APPROVAL FORM FOR UTILITY EASEMENTS

PLACEMENT OF A FIBER OPTIC DROP FROM AN EXISTING TERMINAL LOCATION TO A CUSTOMER ADDRESS AT 3111 SE MCKINNEY ST.

UTILITY PERMIT APPROVAL

Date:	06-26-2026
Application/Permit No.:	00002/20260623/455165/671345/UP
District:	Dallas

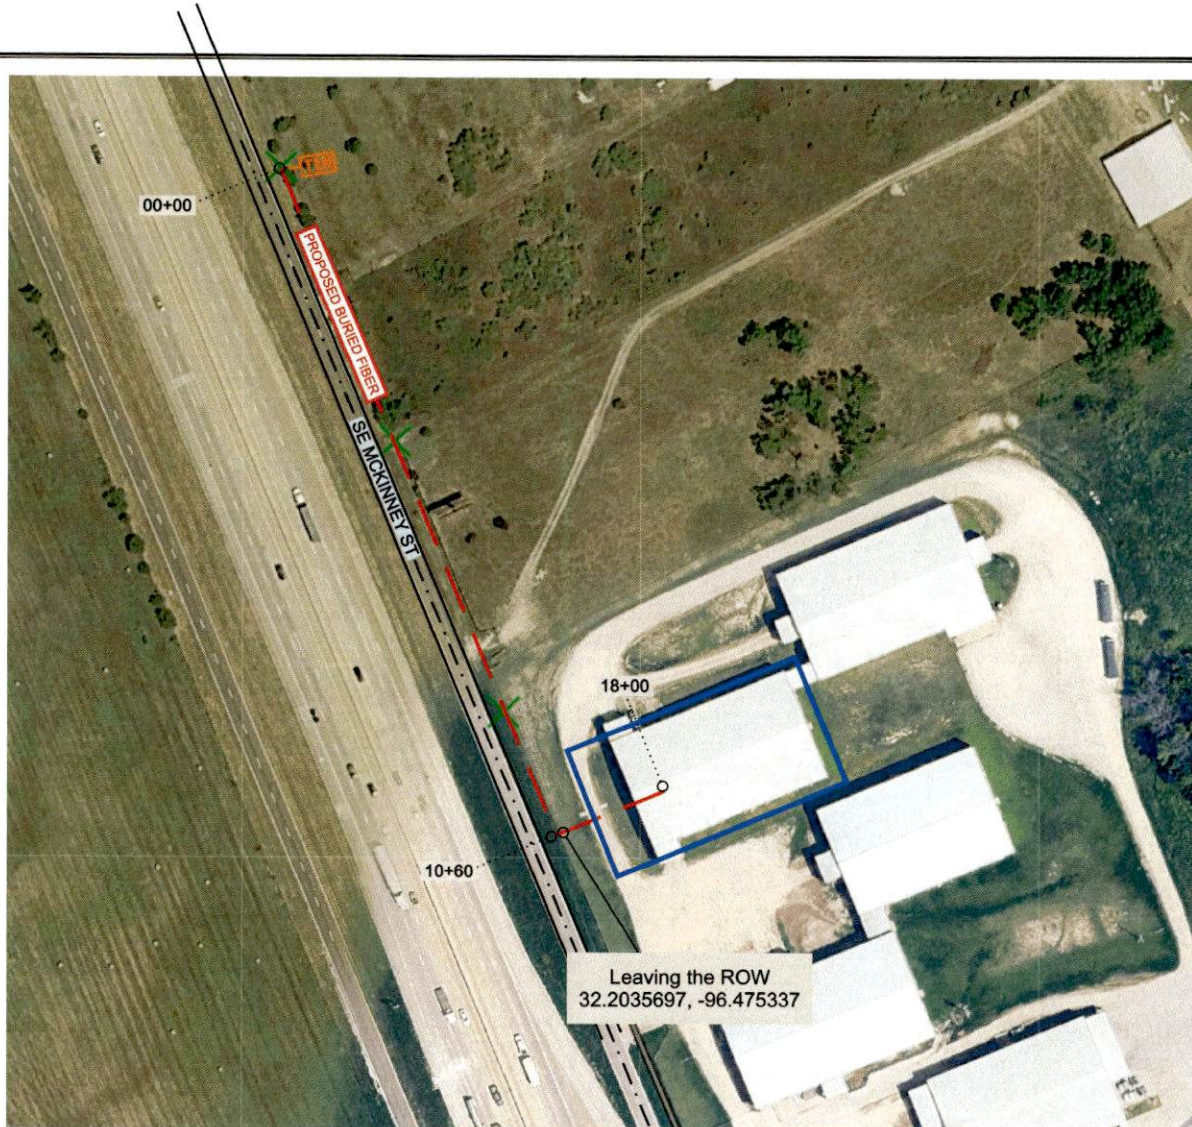
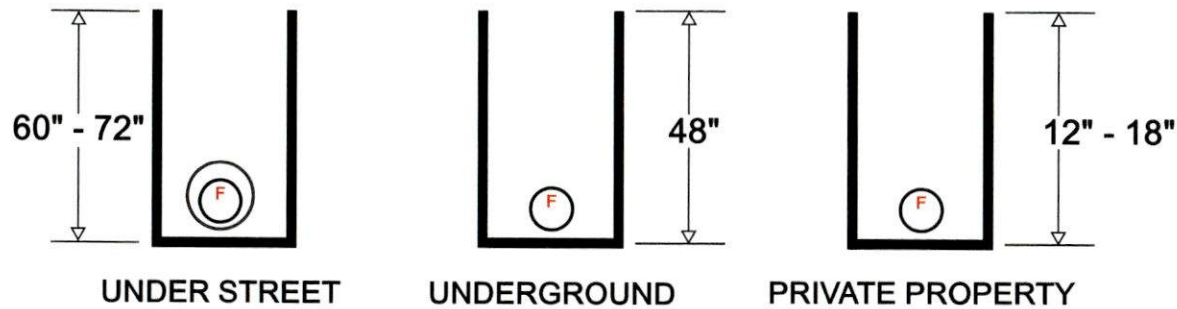
SME - Utility Coordinator Review**Review Answer:** Recommend Approval w/ Comments/Changes**Response text:** 5' min. depth in Txdot ROW.

4' max. distance from outer edge of Txdot ROW.

All boring underground in TxDot ROW is Dry Bore Only.

Permit Approved per submitted drawings. Permit Approval only pertains to TxDOT ROW. DO NOT DEVIATE WITHOUT APPROVAL FROM TxDOT. A hard copy of the permit, approved plans, and approved traffic control will be required on site when the work is performed. Vegetation on ROW will need to be reestablished once work is completed. Please contact TxDot Utility Coordinator 72 hours prior to commence work to notify of when work will start and obtain approval for traffic control. Please NOTE: Failure to contact Utility Coordinator to inform of work starting and to obtain an approved traffic control before starting work may result in all work stopping until obtaining an approved traffic control to perform work. It is understood that it is the responsibility of the utility owner to contact TxDOT 72 hrs. prior to the start of construction using the RULIS System and by email or phone call to the area office Utility Coordinator. It is also the owner's responsibility to contact TxDOT once the construction is complete. Owner is required to notify 811 for locates. Notify DAL-LOCATES@TXDOT.GOV , or call 214-320-6682 when applicable on project for traffic lights, or any other TxDot illuminated signage.
